SLEMA
January 2011
Environmental Update

January 31, 2011

1.4 #2010-458 Spill Analysis

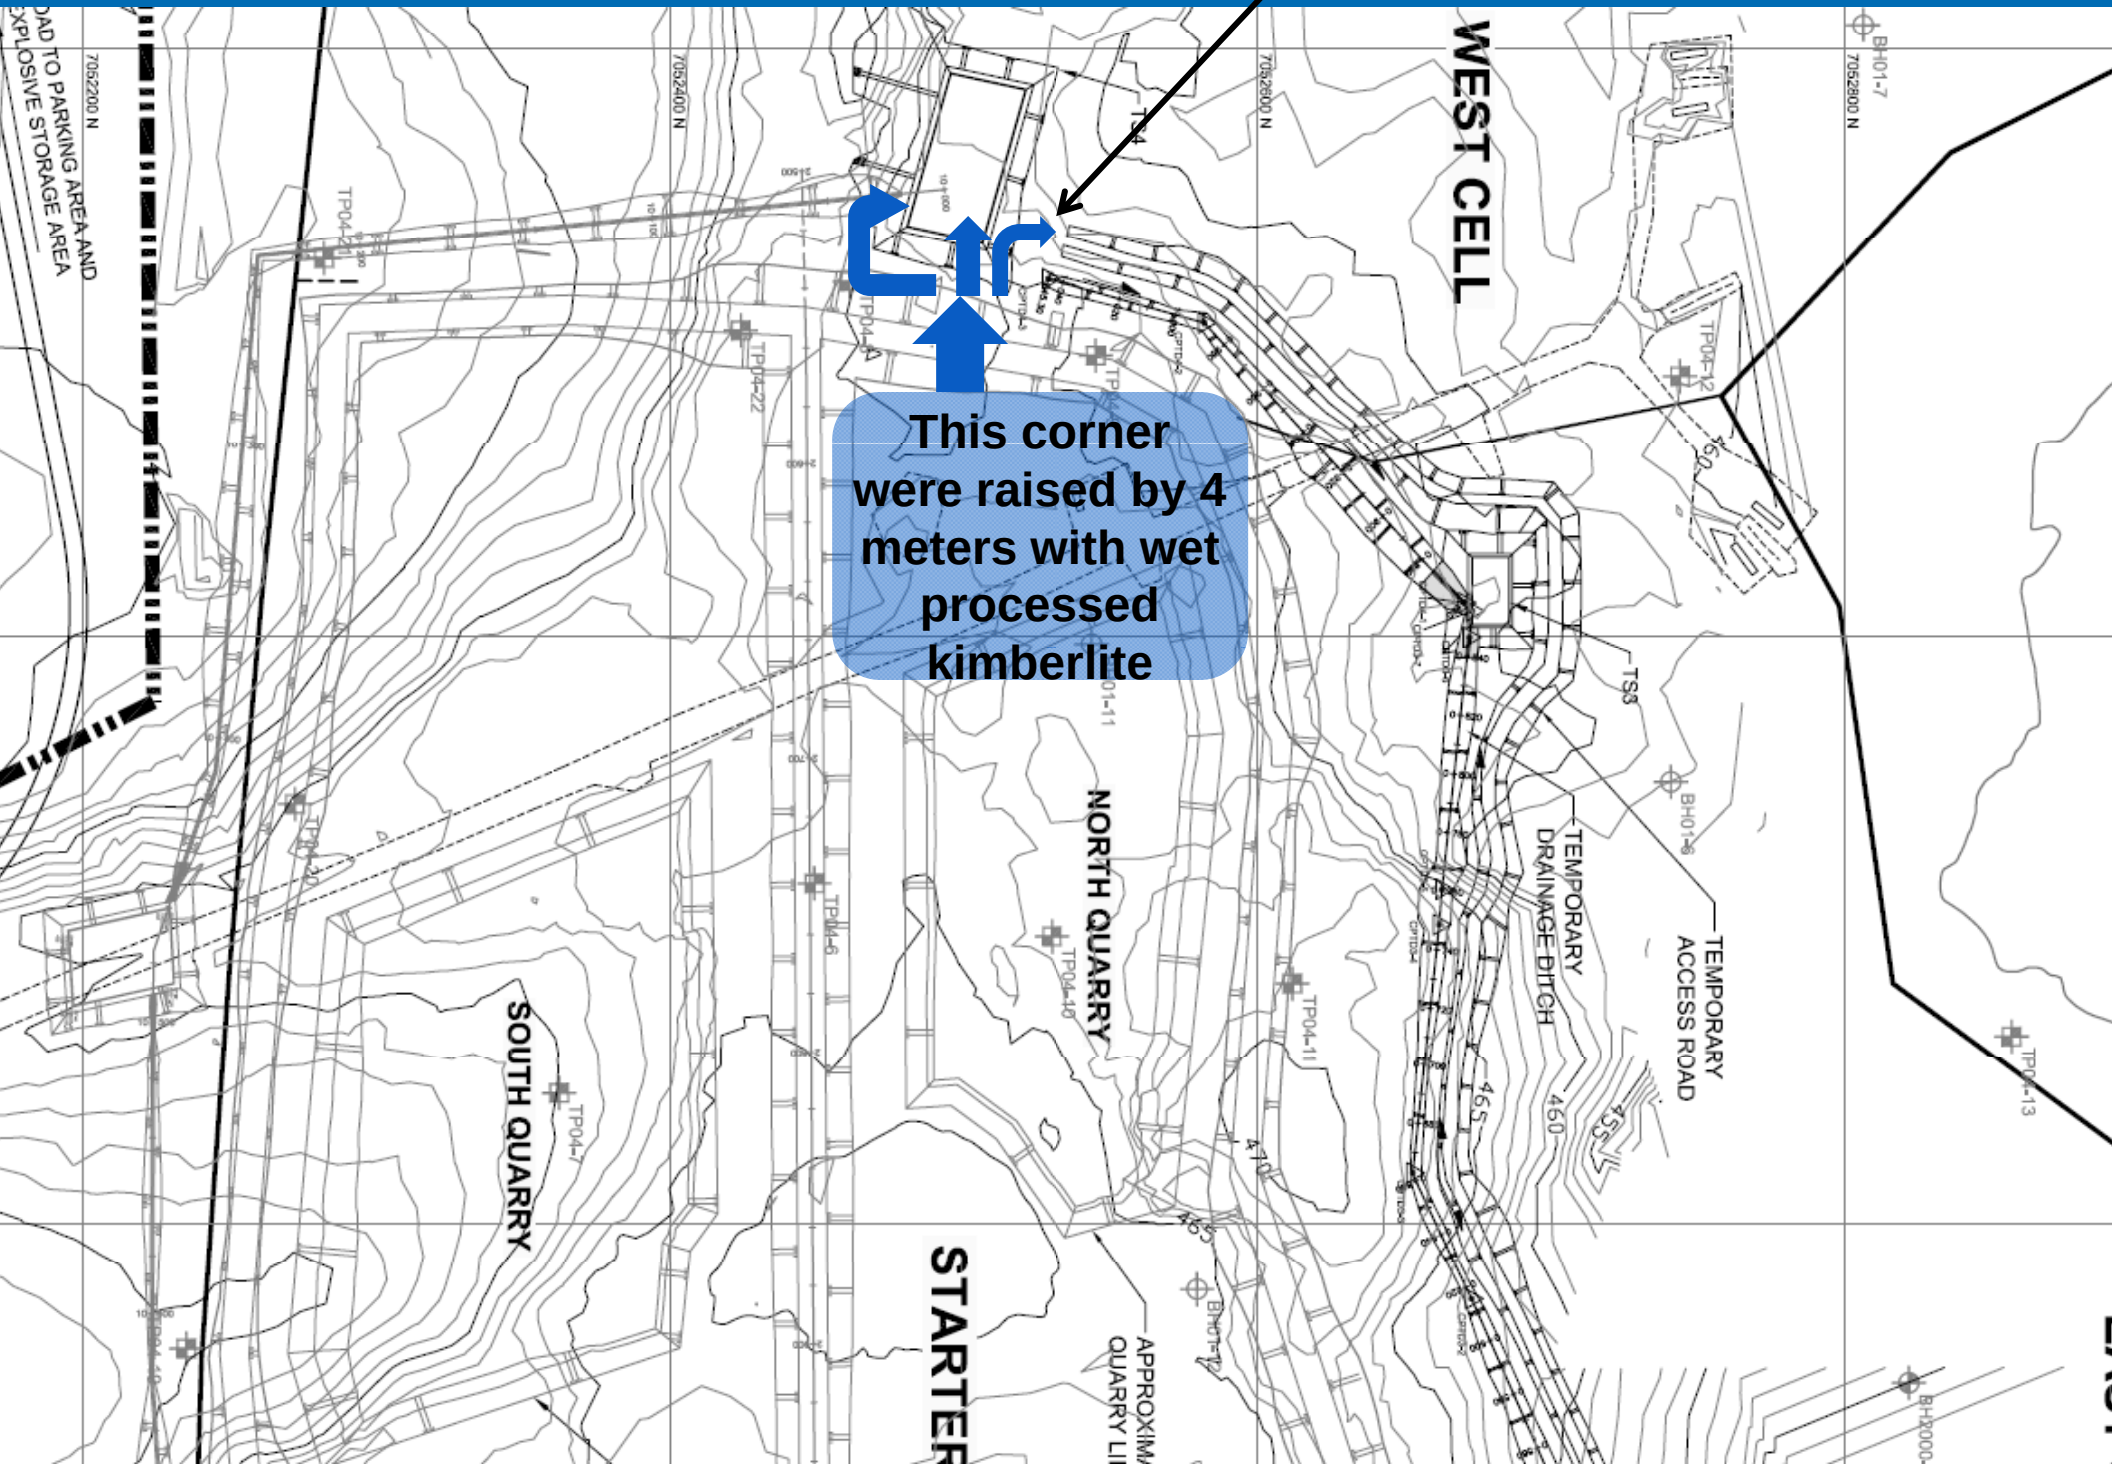
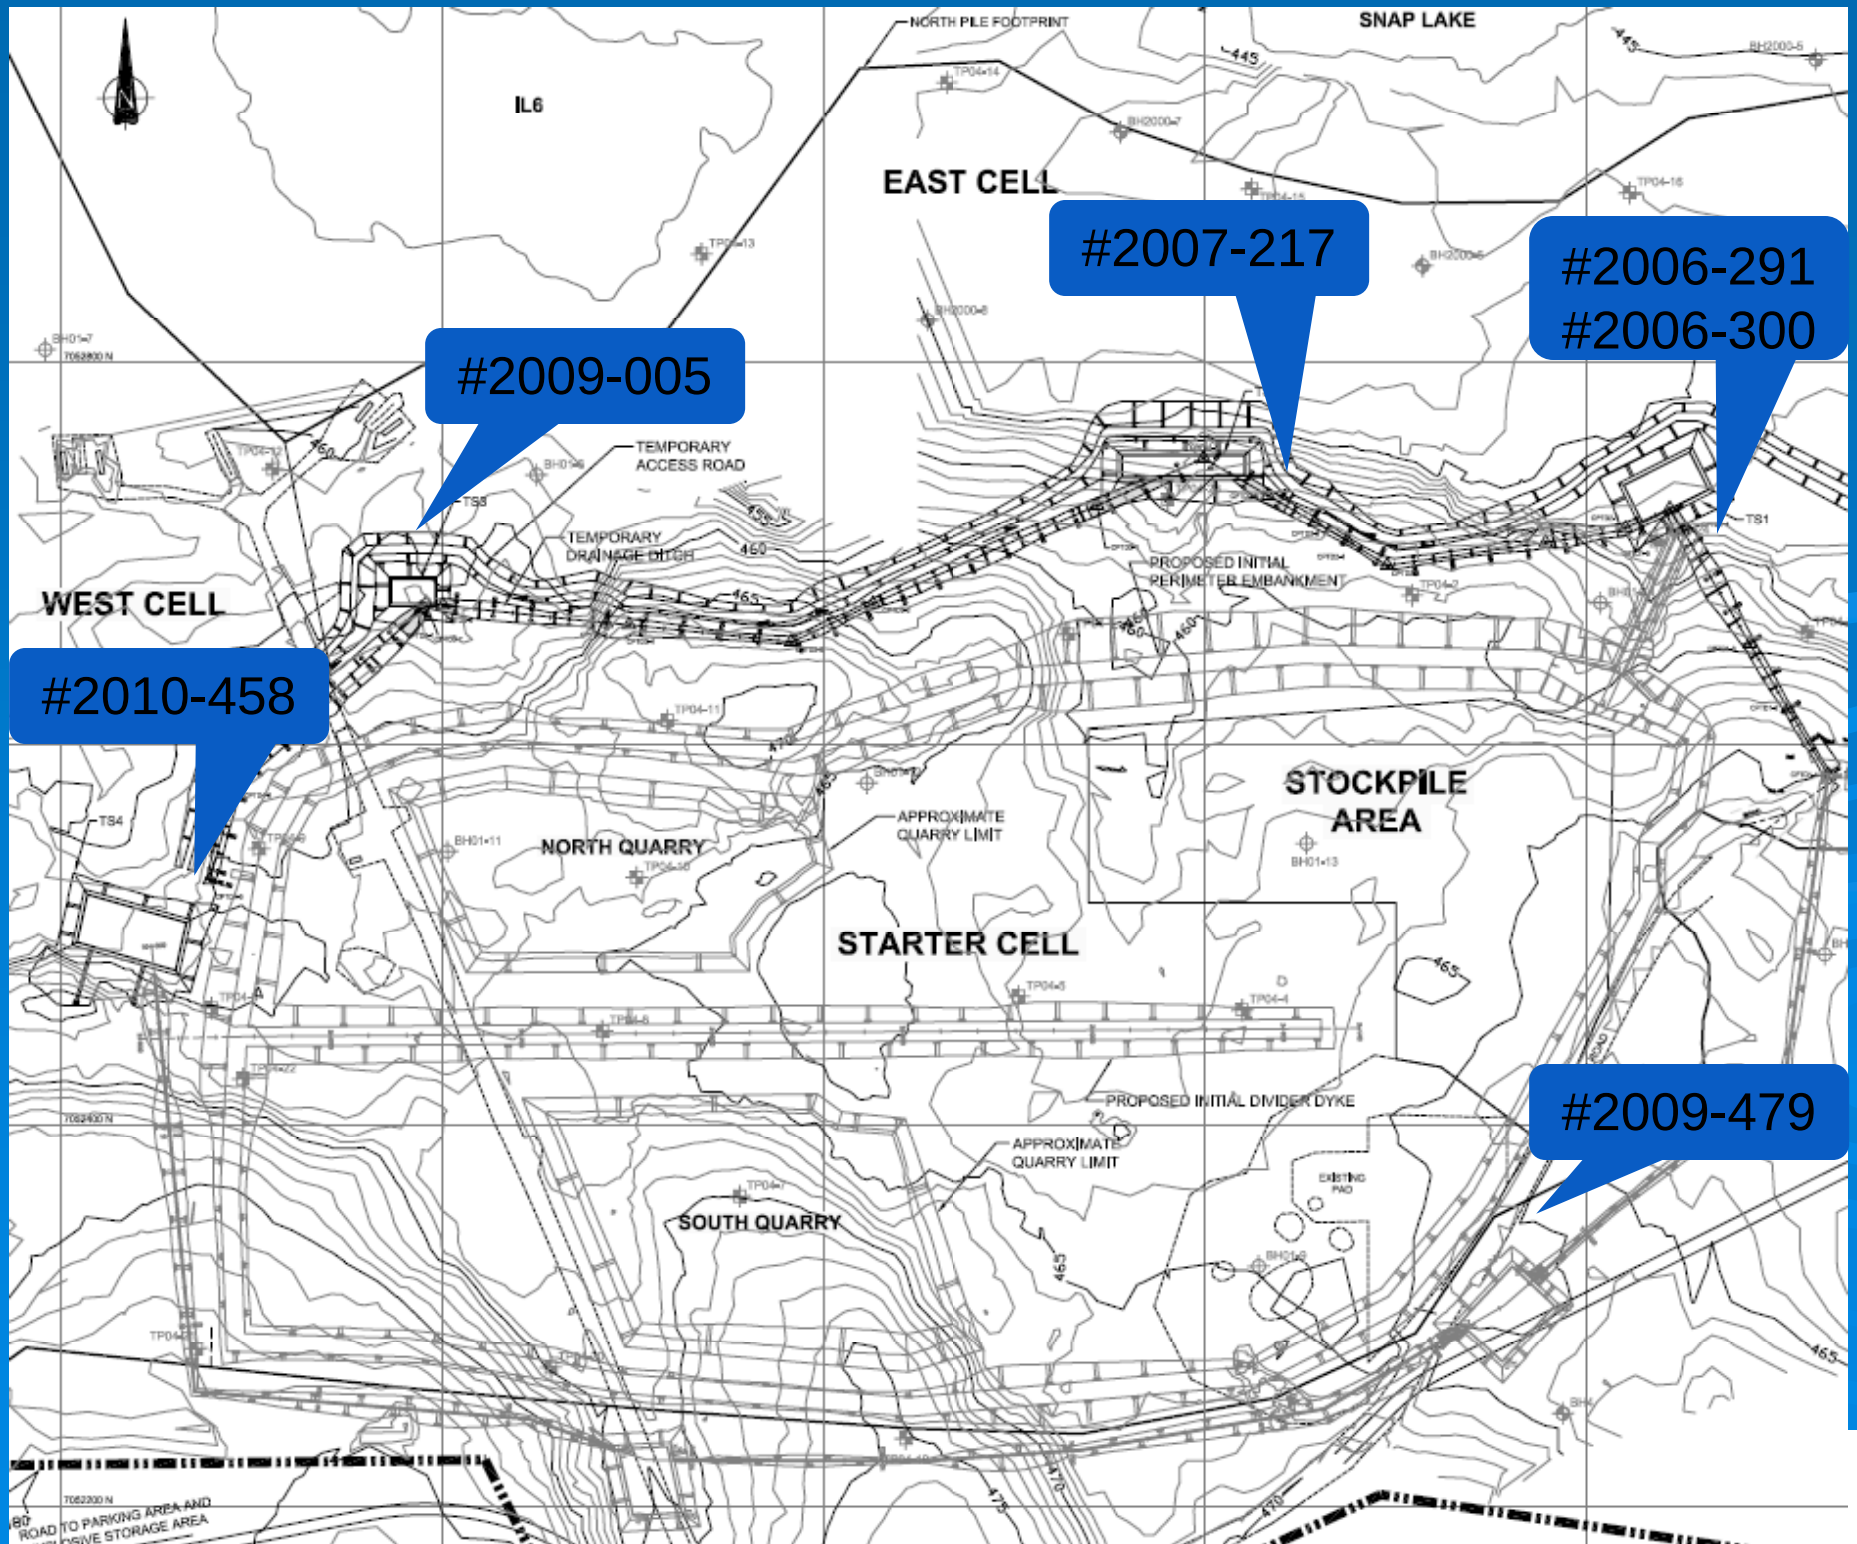
- The spill may be partly caused by design
  defect
  - Rerouting the access road may be a possibl
    longer term solution
- 6 spills within the North Pile (Starter Cell)
  ootprint since 2006
  - There may be chances of spills within the Ea
    Cell in the future
  - SLEMA should closely watch the constructio
    and operation of the East Cell
